Project Name: * Widening of I-95 to Eight lanes from South of SR 1832 (Murphy Road) to South of SR 1811 (Bud Hawkins Road)

Subject: Revised Modification Request for Section 404 Individual Permit, and Modification Request for Section 401 Water Quality Certification and Neuse Riparian Buffer Authorization for the Widening of I-95 to Eight lanes from South of SR 1832 (Murphy Road – Exit 56) to South of SR 1811 (Bud Hawkins Road – Exit 70), in Cumberland County, STIP No. I-5986A. WBS 47532.3.2.

WETLAND AND SURFACE WATER IMPACTS

PERMIT DRAWING
SHEET 1 OF 163

PERMIT DRAWING
SHEET 12 OF 163

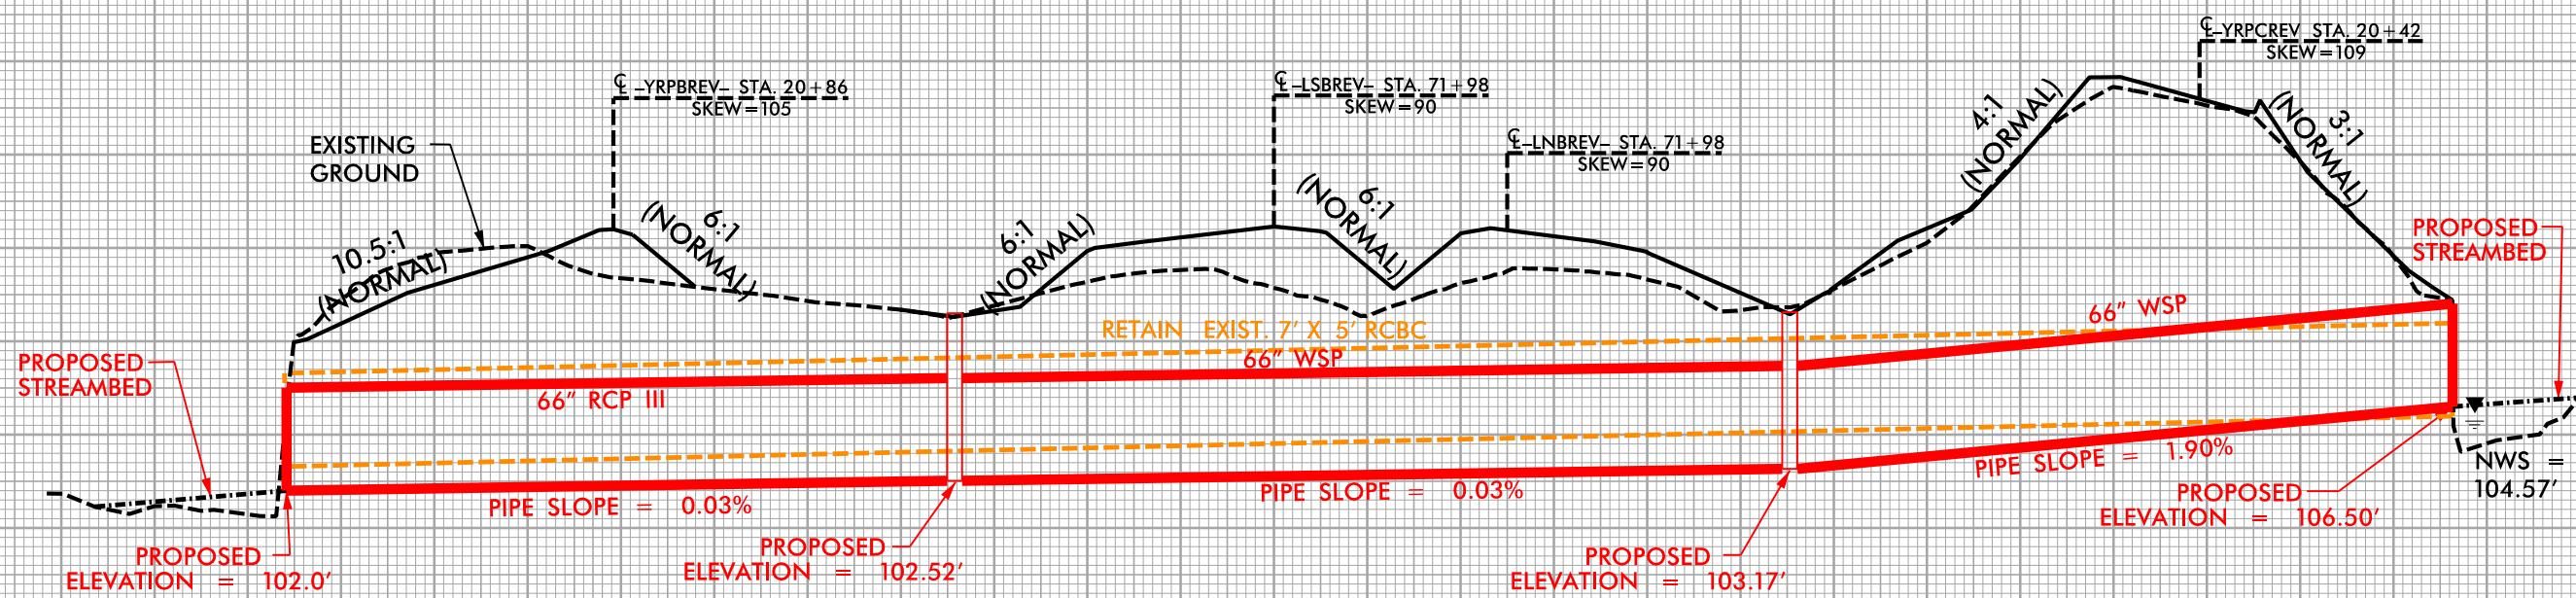
Site 2.

- 0.101 acre increase in permanent fill in wetlands
- 0.001 acre decrease in temporary fill in wetlands
- 0.068 acre increase in mechanized clearing in wetlands
- 62 linear feet increase in permanent stream impacts
- 37 linear feet decrease in temporary stream impacts

PERMIT DRAWING
SHEET 15 OF 163

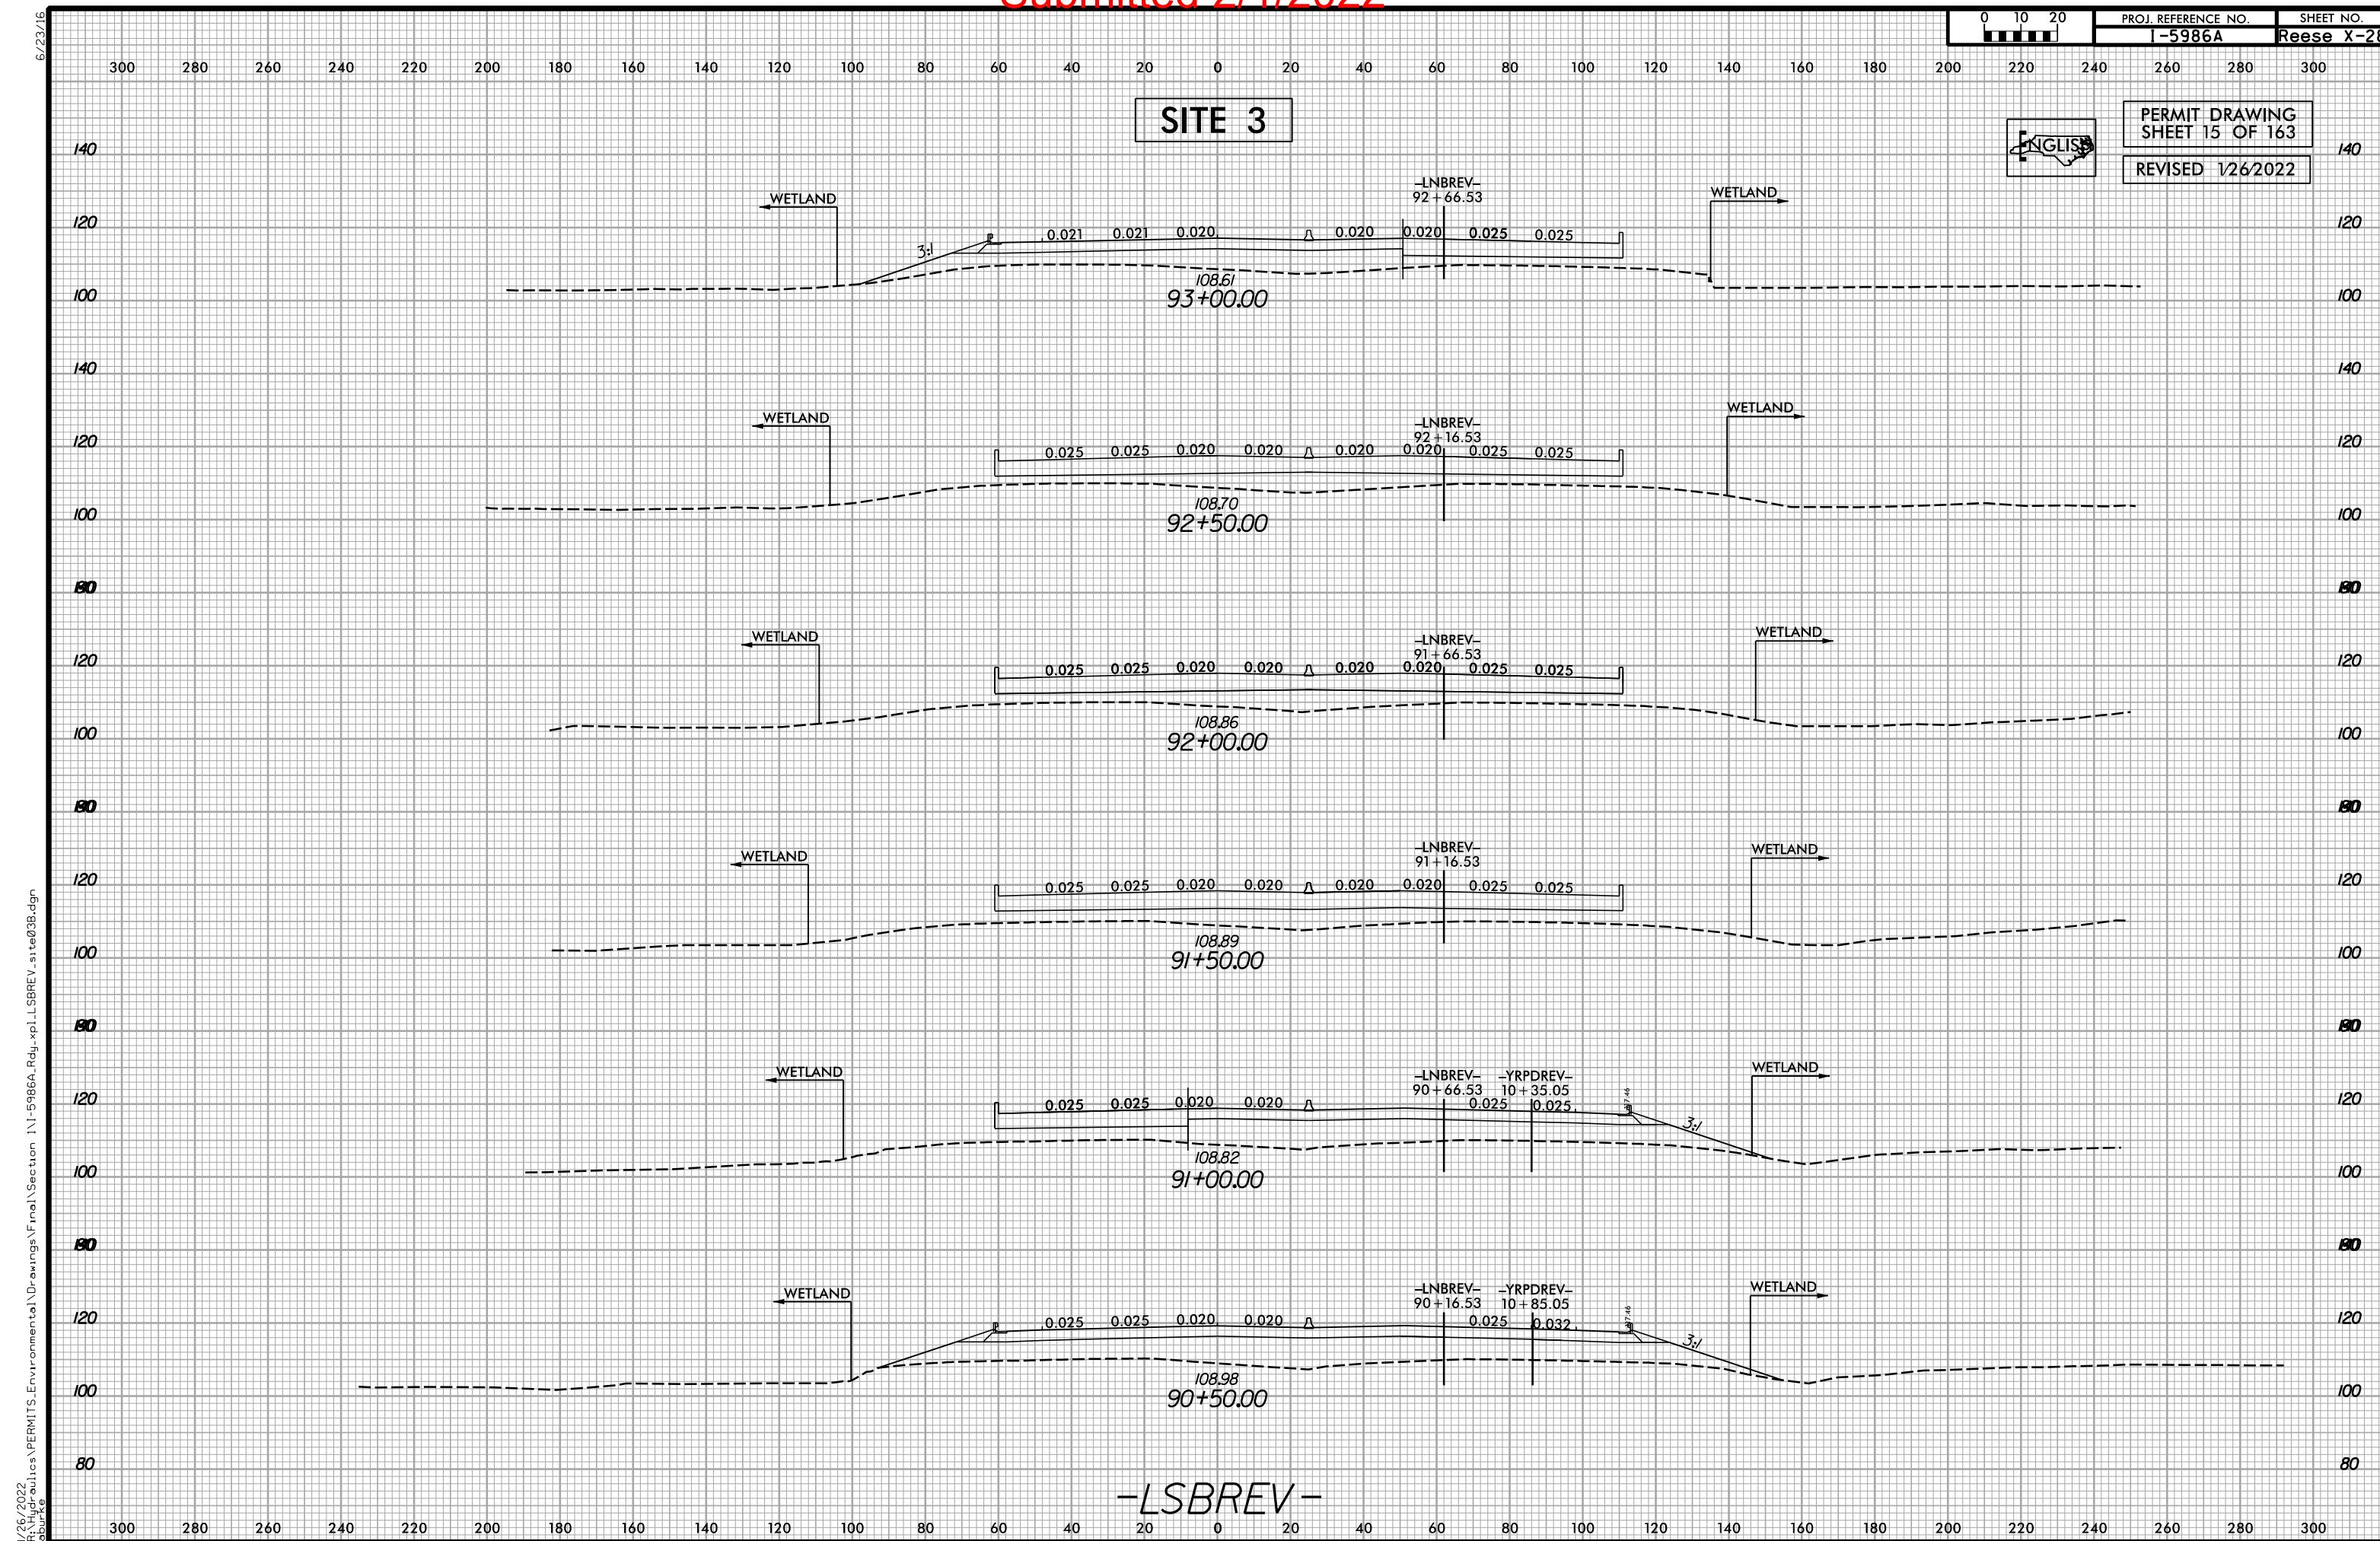
Site 3.

- 0.071 acre increase in permanent fill in wetlands
- 0.050 acre increase in temporary fill in wetlands
- 0.096 acre increase in mechanized clearing in wetlands
- 48 linear feet increase in temporary stream impacts
